**MONTGOMERY COUNTY HISTORIC PRESERVATION COMMISSION**  
**STAFF REPORT**

<b>Address:</b>	6 Montgomery Avenue, Takoma Park	<b>Meeting Date:</b>	9/23/2020
<b>Resource:</b>	Non-Contributing Resource <b>Takoma Park Historic District</b>	<b>Report Date:</b>	9/16/2020
<b>Applicant:</b>	Elliott Andalman (Aaron Williams, Agent)	<b>Public Notice:</b>	9/9/2020
<b>Review:</b>	HAWP	<b>Tax Credit:</b>	No
<b>Case Number:</b>	37/03-20UUU	<b>Staff:</b>	Michael Kyne
<b>PROPOSAL:</b>	Solar panel installation

**PROPOSAL**

*Fig. 1: Subject property.*

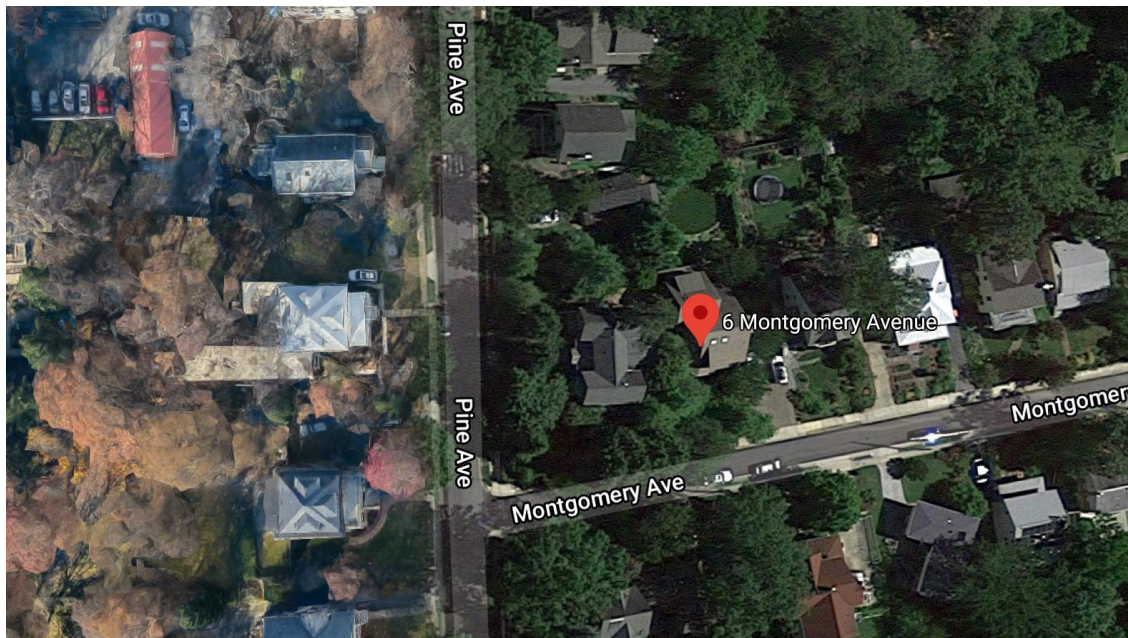
The applicant proposes to install 10 roof-mounted solar panels at the subject property. The solar panels will be installed on the southern (front) roof slope of the main house.

Staff finds the proposal to be consistent with the Commission's solar policy. The subject property is moderately forested, and the house is oriented with its front to the south, making it infeasible to install the proposed solar panels in a preferred location (on the rear of the property, building additions, accessory structures, or ground-mounted arrays). Also, because the resource is a c. 1980s Non-Contributing Resource, the roof is neither architecturally significant, nor a character-defining feature of the resource, nor is it a slate or tile roof.

The proposal is not a major addition or alteration to the scale and massing that will affect the surrounding streetscape and/or landscape or impair the character of the historic district as a whole. Therefore, in accordance with the *Guidelines* for Non-Contributing Resources, the proposal should receive the most lenient level of design review, and most alterations should be approved as a matter of course.

In accordance with *Standards #2* and *#9*, the proposal will not remove or alter character-defining features of the subject property or surrounding streetscape.

Staff recommends that the Commission approve the HAWP application under the Criteria for Issuance in Chapter 24A-8(b), (1), (2) & (d) having found that the proposal is consistent with the *Takoma Park Historic District Guidelines*, and therefore will not substantially alter the exterior features of the historic resource and is compatible in character with the district and the purposes of Chapter 24A;
